Re: Good Counsel Planned Unit Development #2 Submission (Phase 1 Amendment)

**Good Counsel – Main Campus
Mankato, MN**

HYDRAULIC DESIGN SUMMARY REPORT

GOOD COUNSEL
SITE PLAN - OVERALL

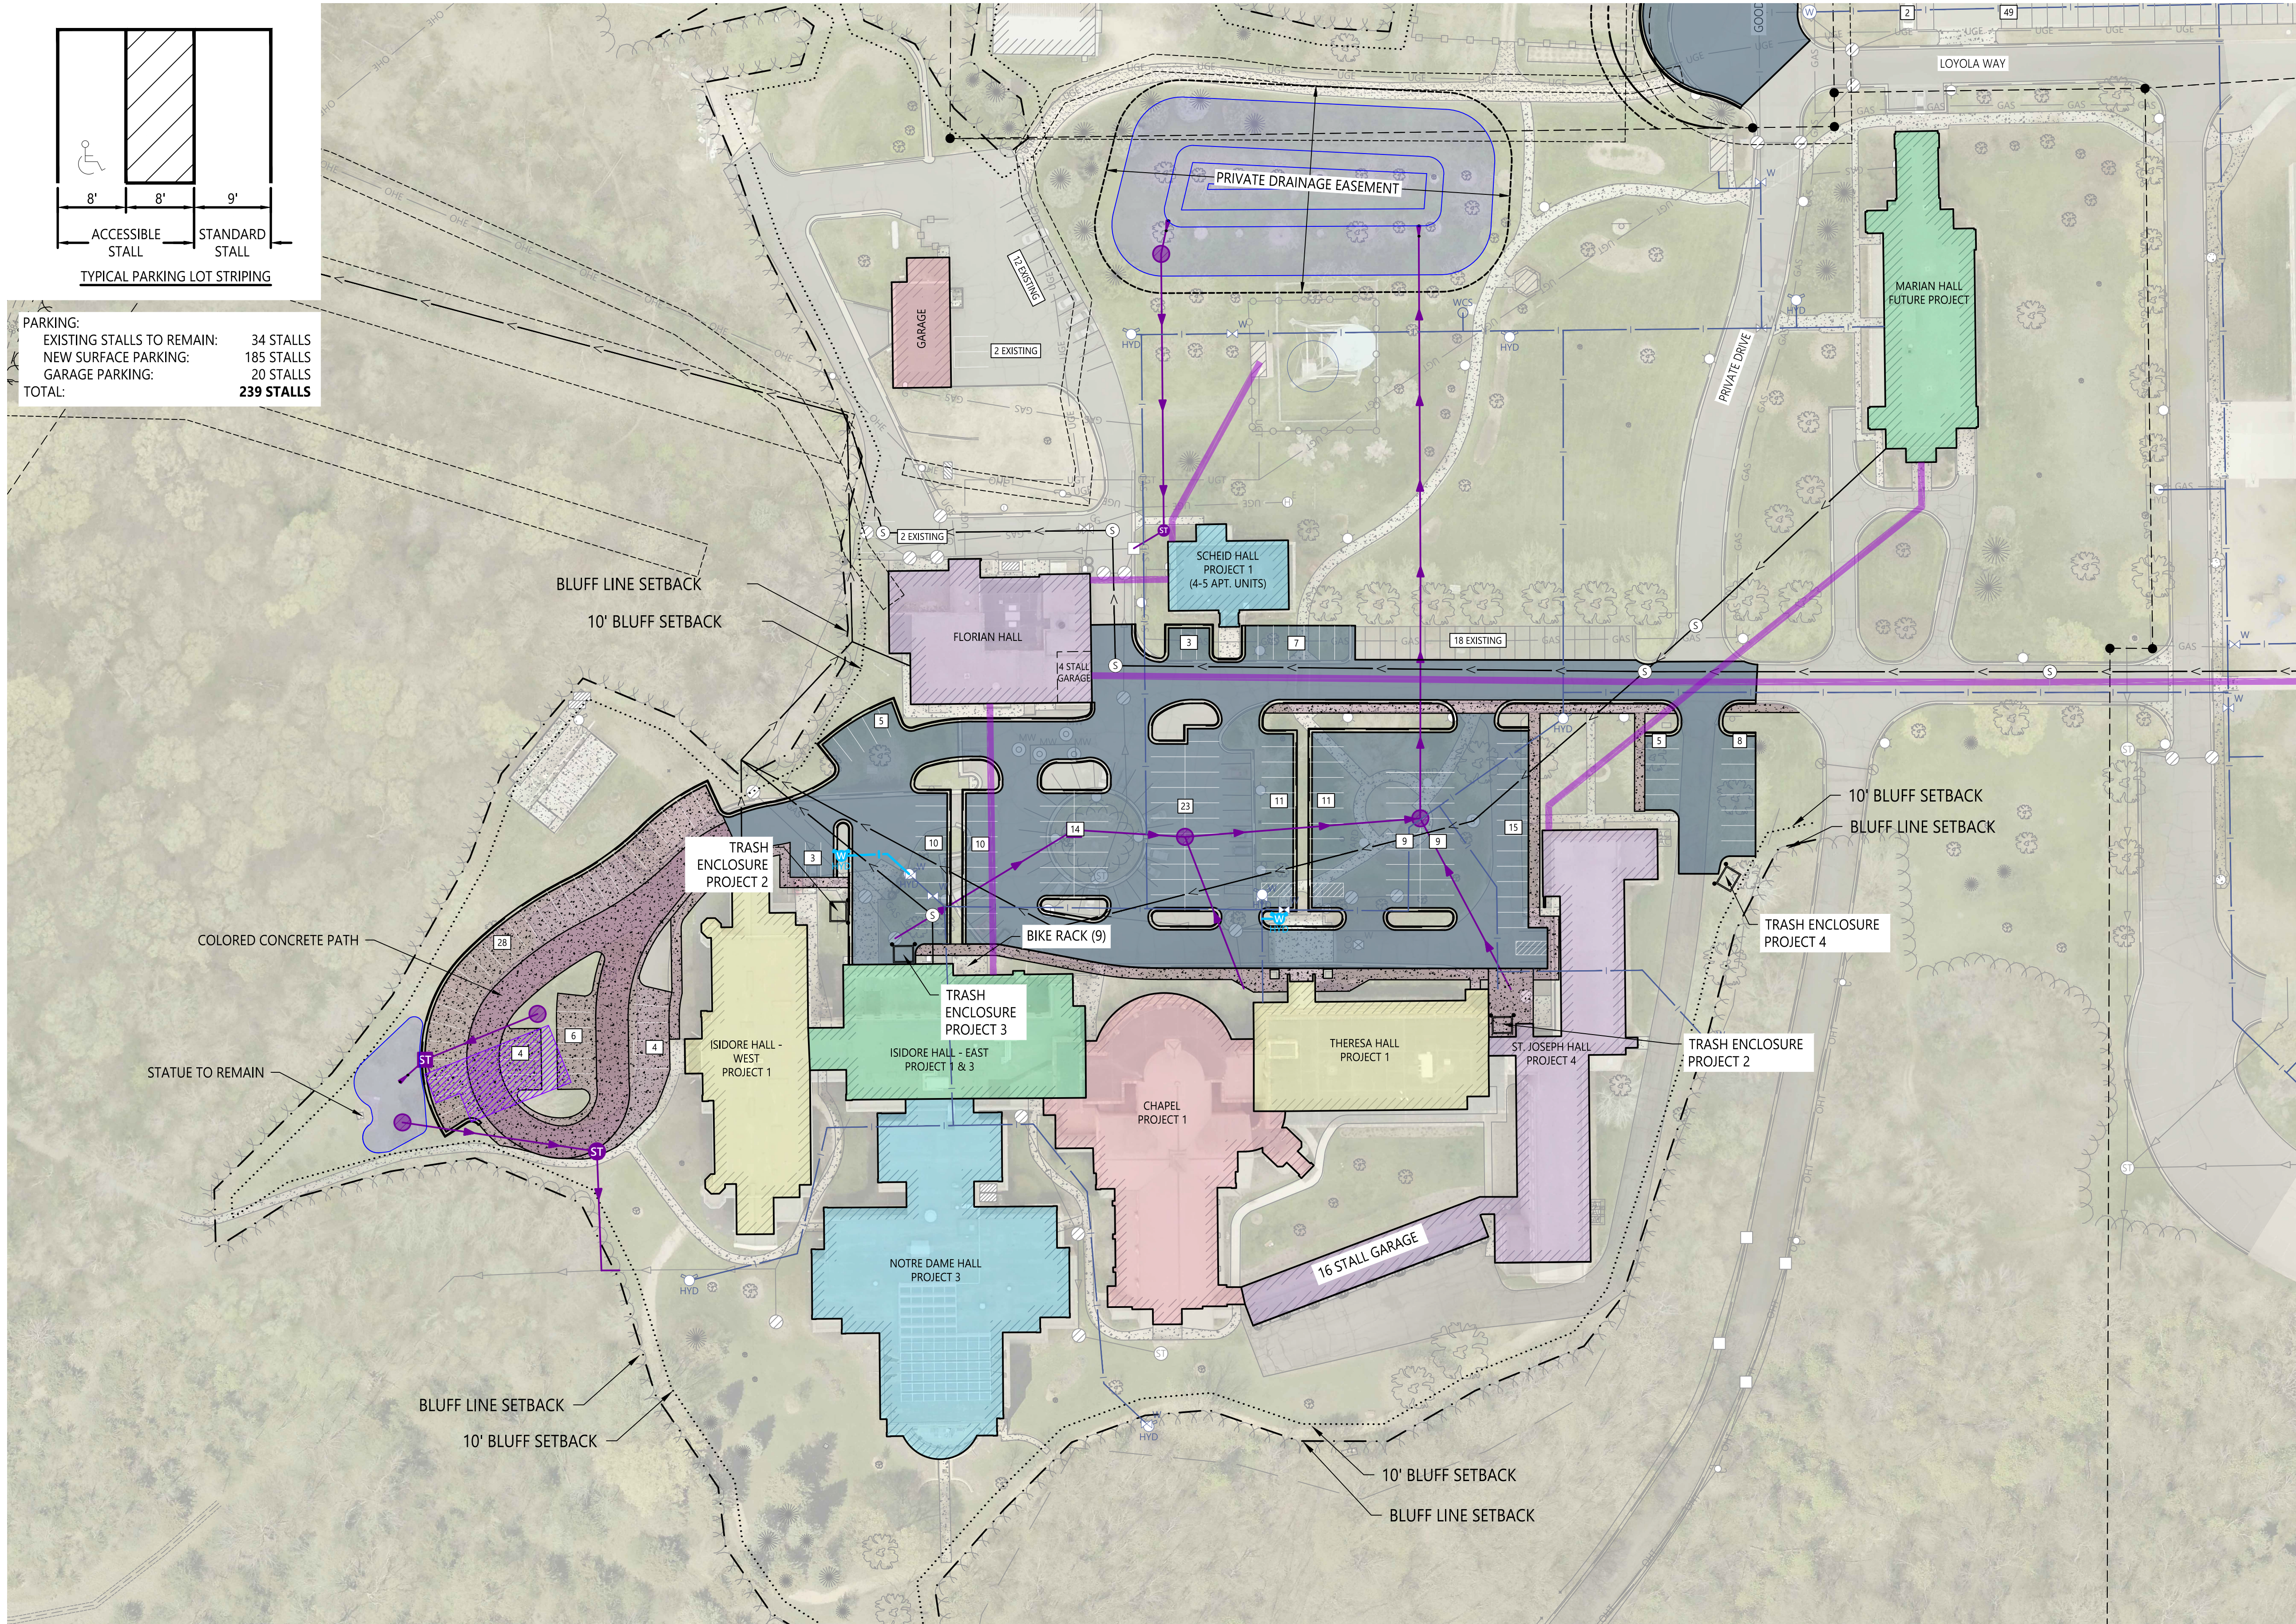
- 1) A total of 239 parking spots to be constructed, and associated stormwater management plans. SWMHP is requesting that this number be approved to be adequate to support the uses in the original PUD approval (with minor amendments as outlined below)
- 2) The residential re-use of Scheid Hall for up to 5 residential units

A total of 239 parking spots, and associated stormwater management infrastructure are planned to be constructed as part of the adaptive re-use projects associated with the

Based on balancing all these factors, SWMHP is proposing a total of 239 stalls located on the included site plan. **SWMHP specifically requests that this parking plan be approved to satisfy the parking needs of the above uses, with the addition of allowances/requirements for shuttles for unlimited large events (over 100 people attending). If this request cannot be accommodated, SWMHP asks that the City put a denial of the parking plan/allowance request in the resolution to be submitted with the SHPO Part 2 Historic Review application. SWMHP must show that efforts are being made to minimize historic and environmental impact through a PUD for parking as proposed in order to move forward in SHPO review.**

PARKING:
EXISTING STALLS TO REMAIN: 34 STALLS
NEW SURFACE PARKING: 185 STALLS
GARAGE PARKING: 20 STALLS
TOTAL: 239 STALLS

SCHEID HALL:

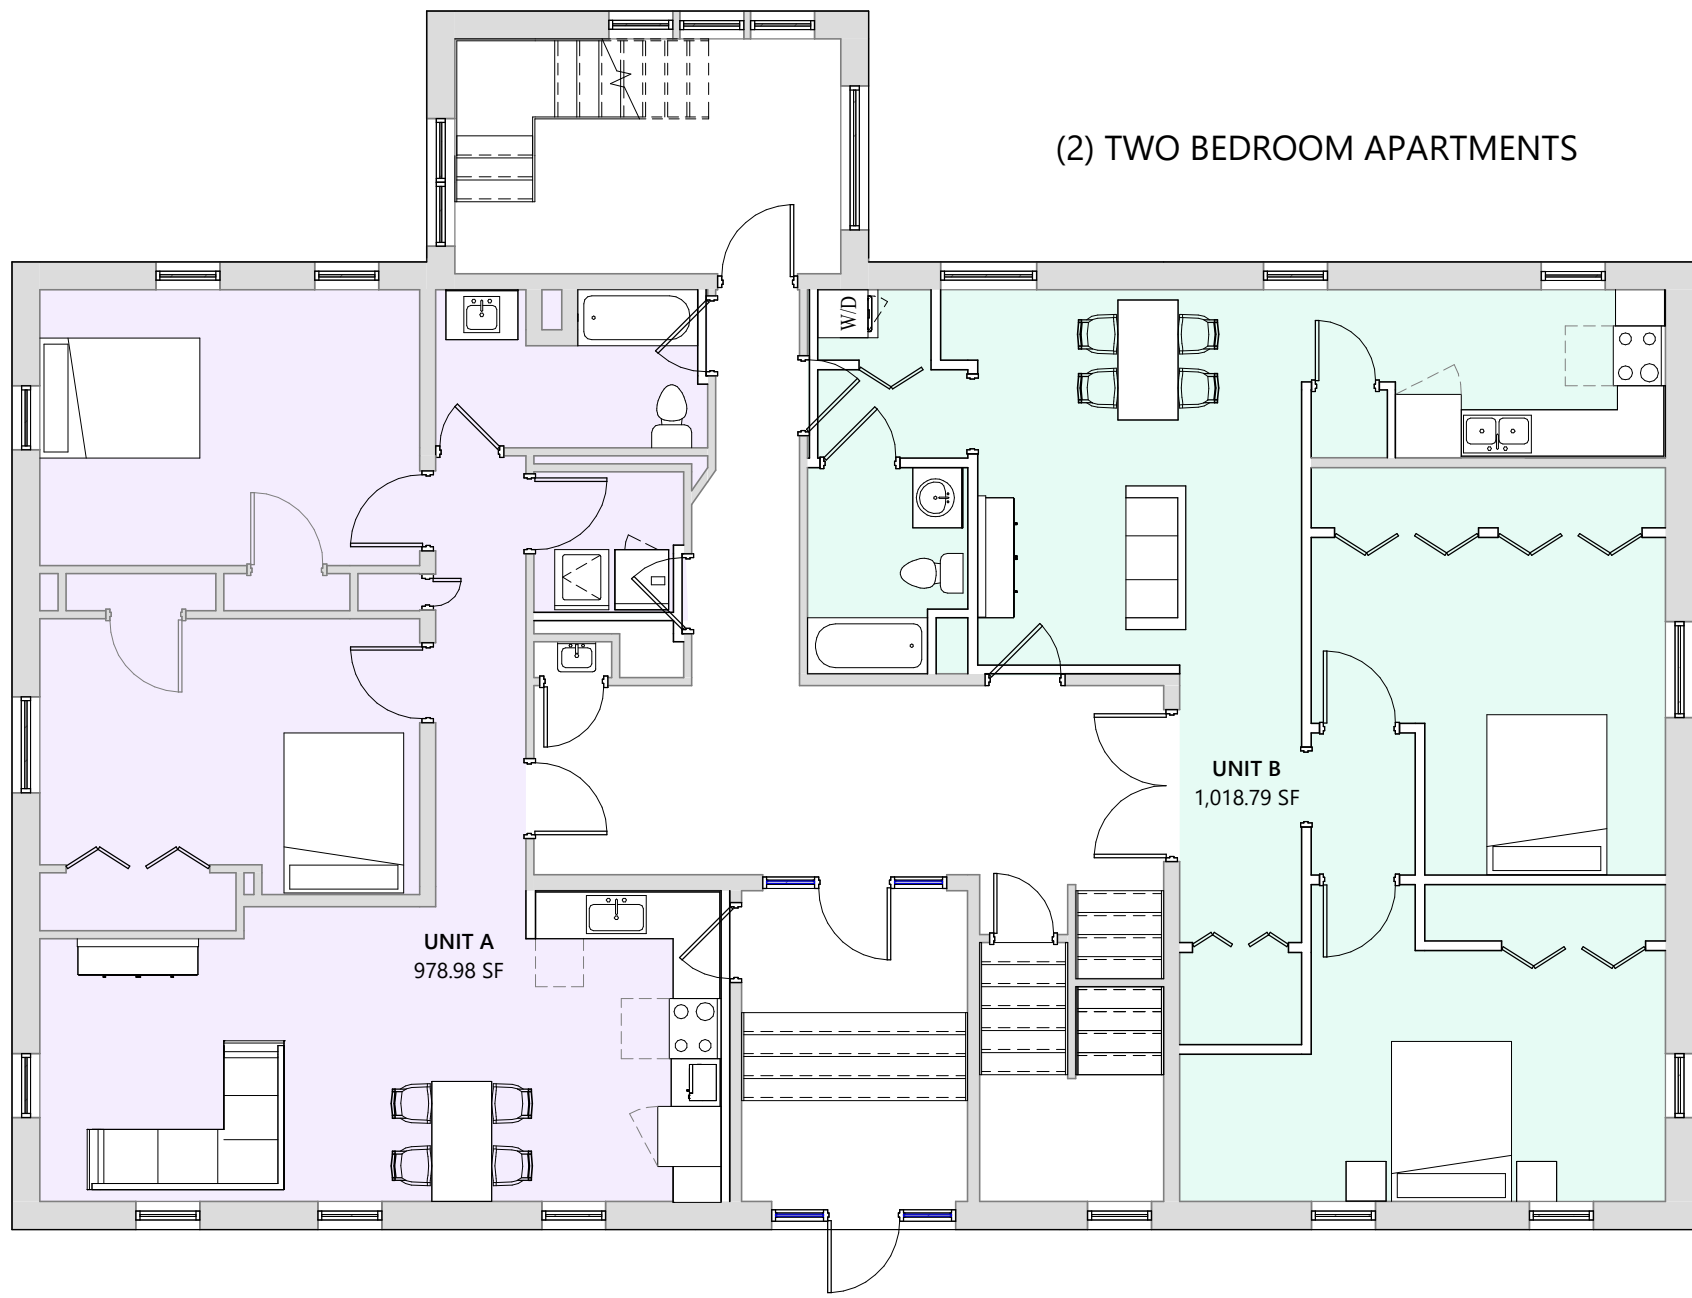
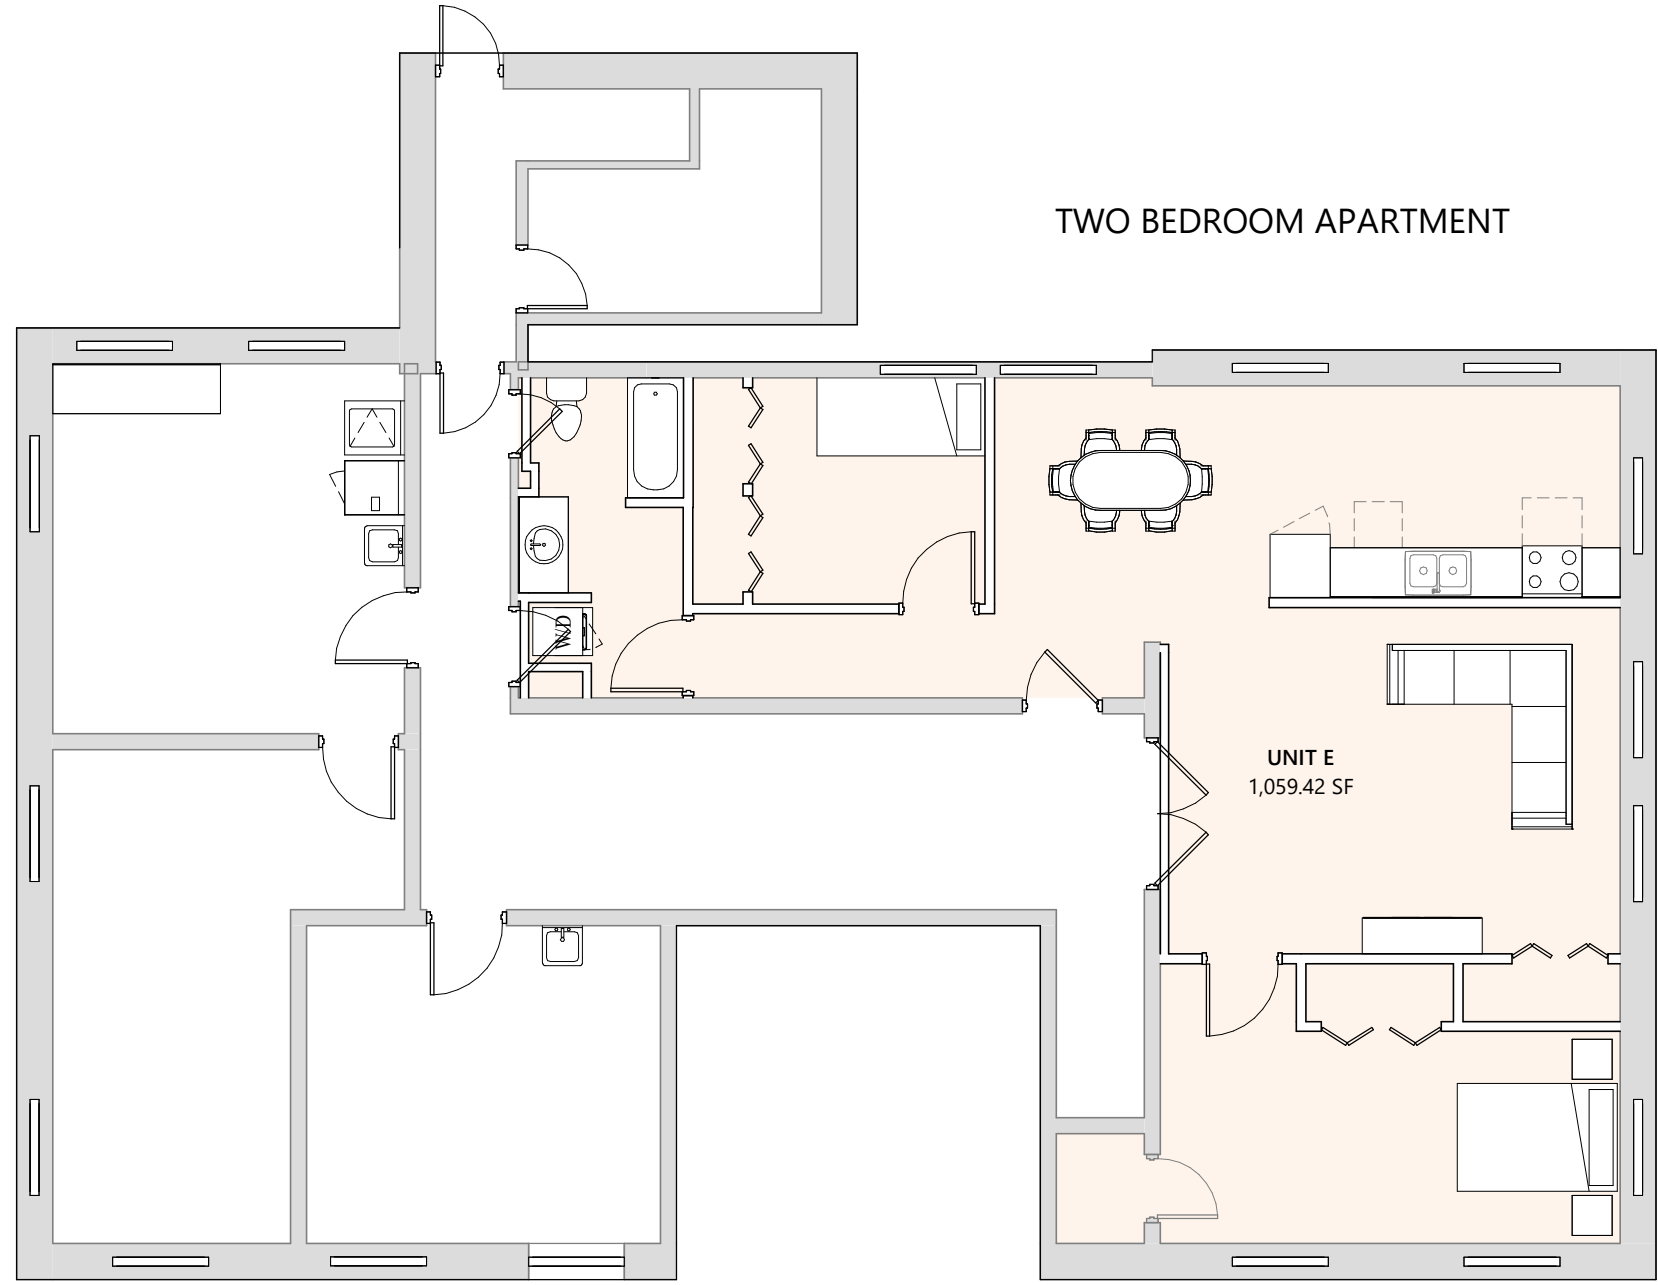
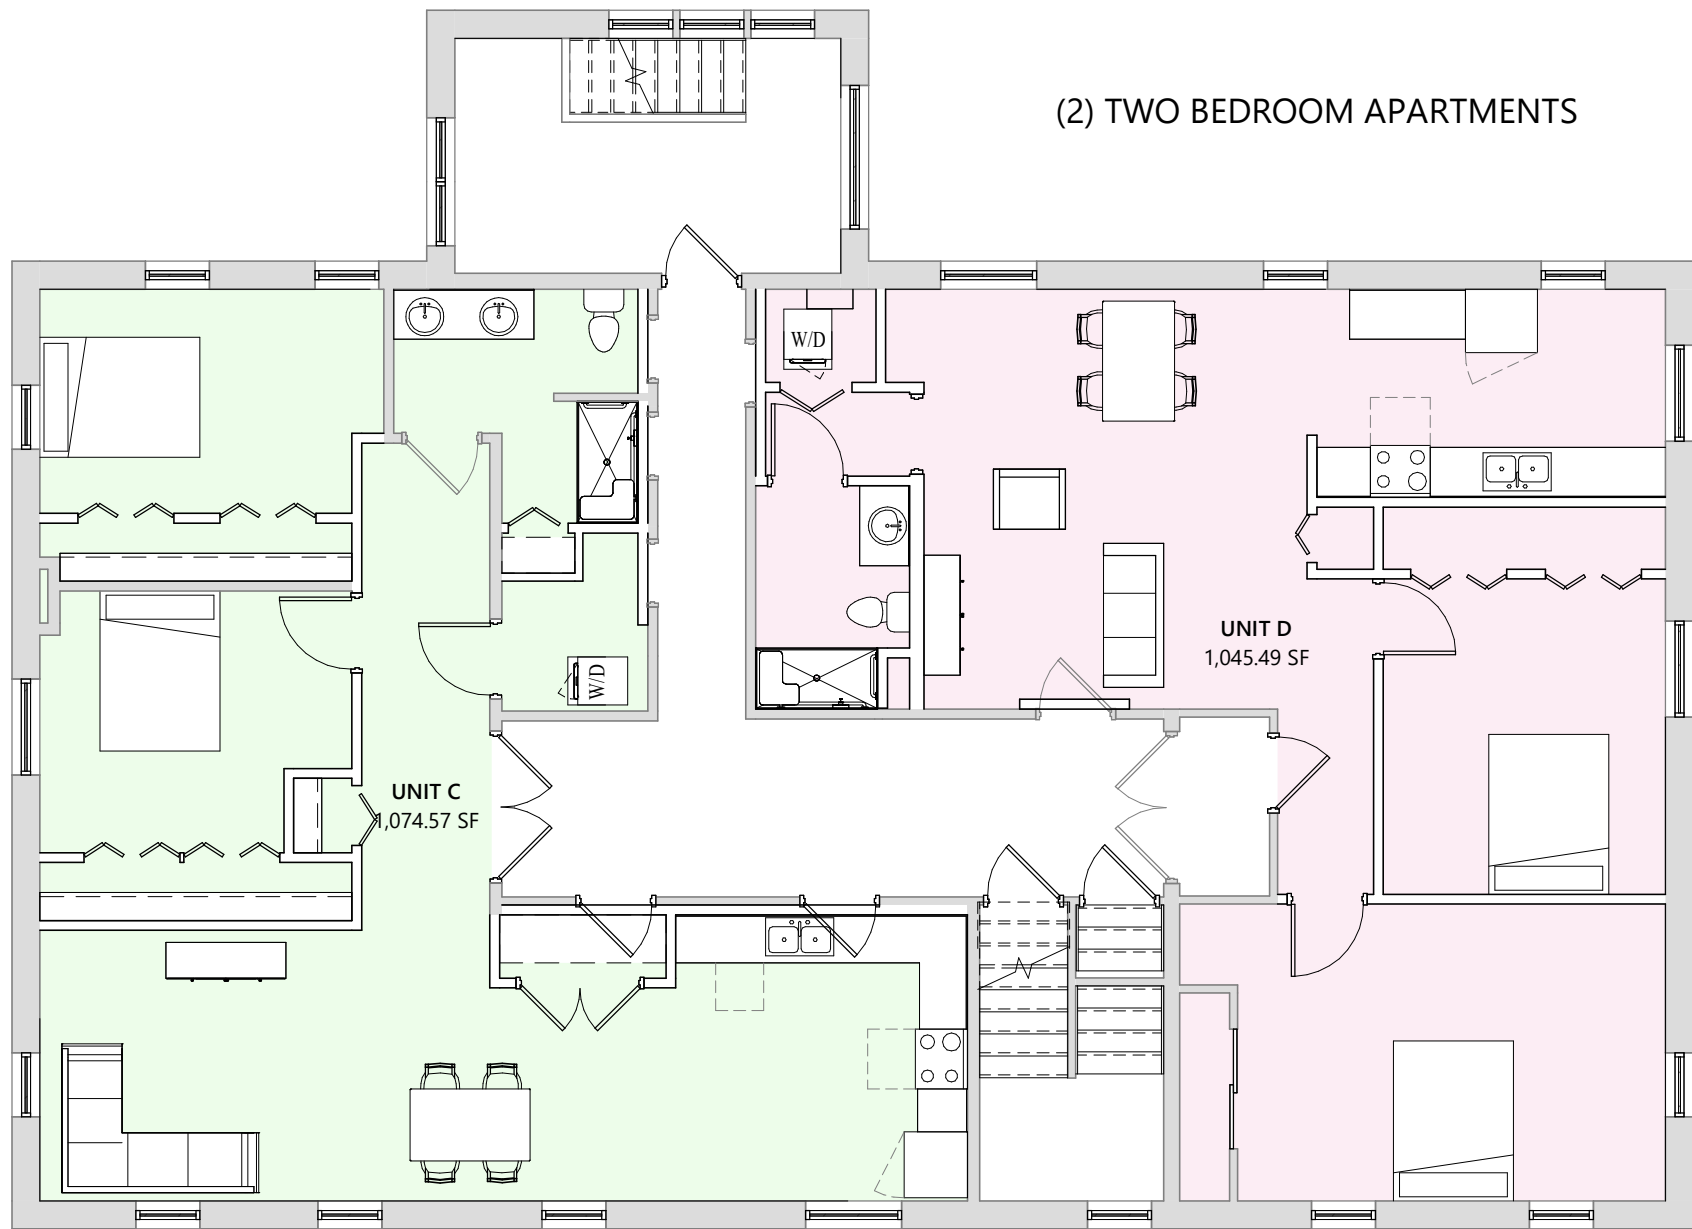
We request evaluation for the residential re-use of Scheid Hall for up to 5 residential units. At the time of PUD approval, the plans for Scheid Hall were not finalized. SWMHP has finalized building permit layouts for Scheid Hall and therefore, seeks to include the use of the building for residential apartments in this amendment. The plans are included for reference and the number of units is reflected in the parking calculation.

SWMHP is asking for a PUD amendment to include Scheid Hall residential units in PUD approval.

FIVE TOTAL PROPOSED TWO BEDROOM APARTMENTS
